Planned Unit Development - Hubbell Development Services, Inc. – Lots 1-3 Mayfair 2nd Addition Replat Seven and Lot 2 Mayfair 2nd Addition Replat Three

Replat - Mayfair 2nd Addition Replat Eight - Hubbell Development Services, Inc. – Lots 1-3 Mayfair 2nd Addition Replat Seven and Lot 2 Mayfair 2nd Addition Replat Three

**CITY OF LA VISTA
PLANNING DIVISION
RECOMMENDATION REPORT**

CASE NUMBERS: PPUD23-0003; PCUP23-0004; FOR HEARING ON: JUNE 15, 2023
PRP23-0002 REPORT PREPARED ON: JUNE 8, 2023

Exhibit A - Sidewalk Additions

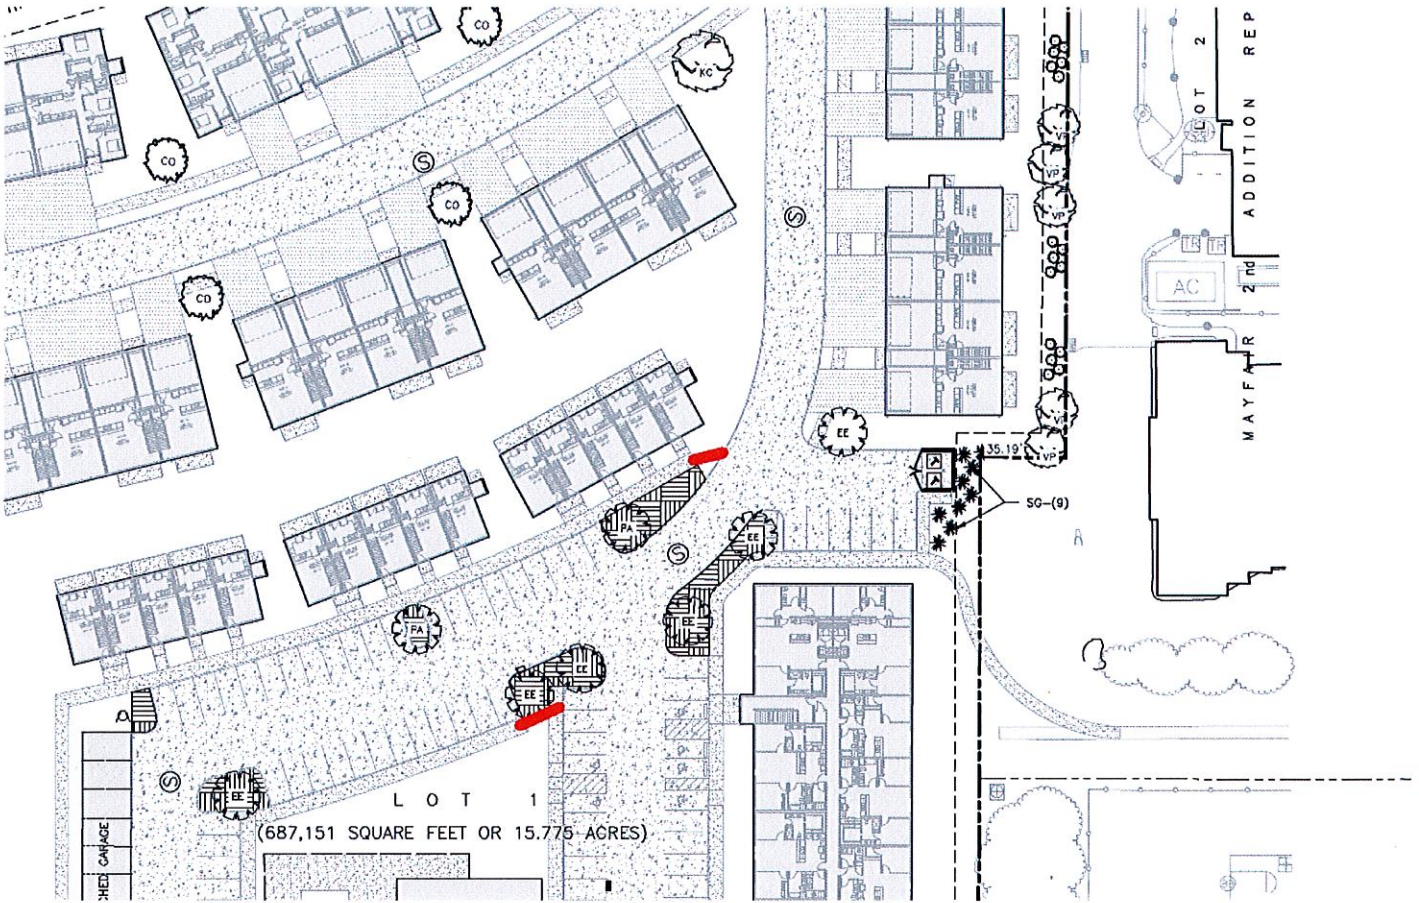
6. Zoning Ordinance Section 5.15.04.07 and 5.15.04.16 – To complete the sidewalk network in the development to provide adequate pedestrian connectivity, please update the plan to include the two sidewalk connections noted in red on the plan in Exhibit A, attached to this letter.

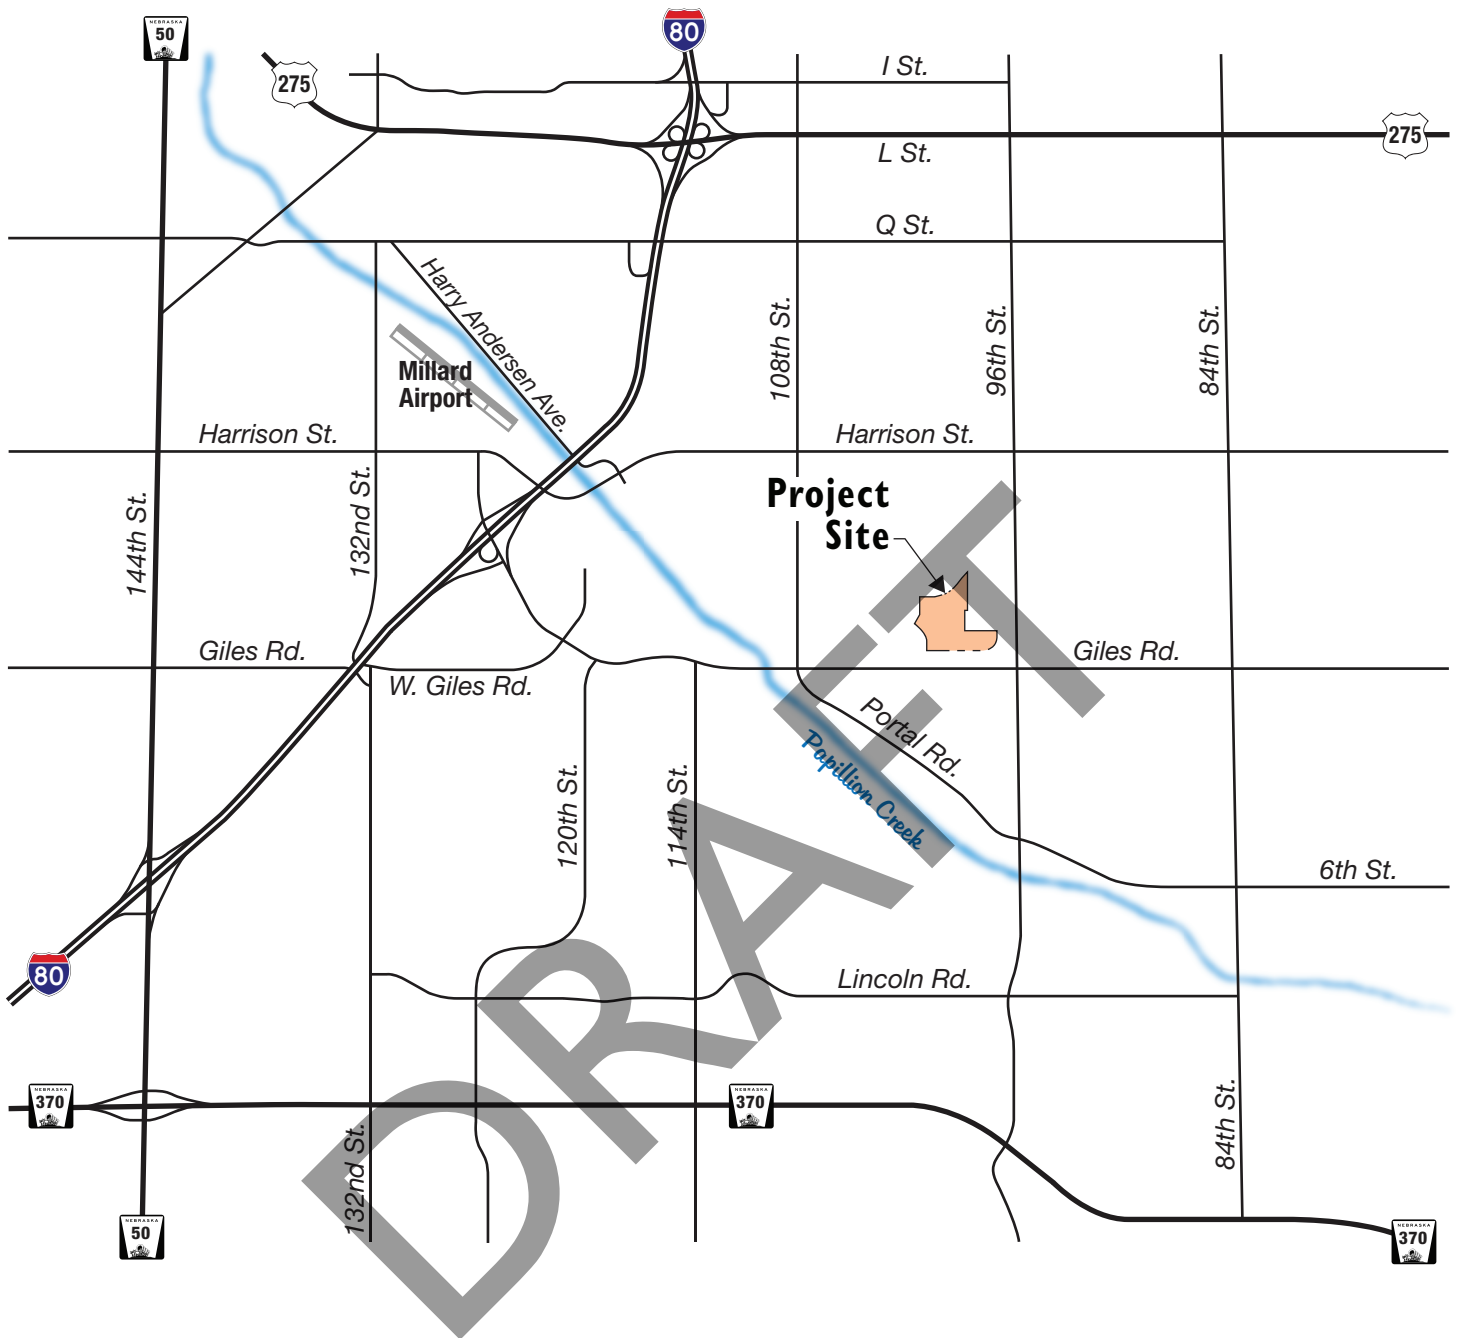
Based on the site plan provide in Figure 2 and the associated development summary table, the number of apartment units listed (2 – 180 units) does not match the number of apartment buildings shown in the site plan (3). **It should be determined if this is a simple labeling error, or if there are additional dwelling units unaccounted for.** *Note: It appears there are 20 units per floor. If each building has 3 floors, the total dwelling units would be 180.*

- Based on the site plan provide in Figure 2 and the associated development summary table, the number of apartment units listed (2 – 180 units) does not match the number of apartment buildings shown in the site plan (3). *Note: It appears there are 20 units per floor. If each building has 3 floors, the total dwelling units would be 180*
- Trip generation rates are consistent with ITE's Trip Generation Handbook and the proposed site characteristics.
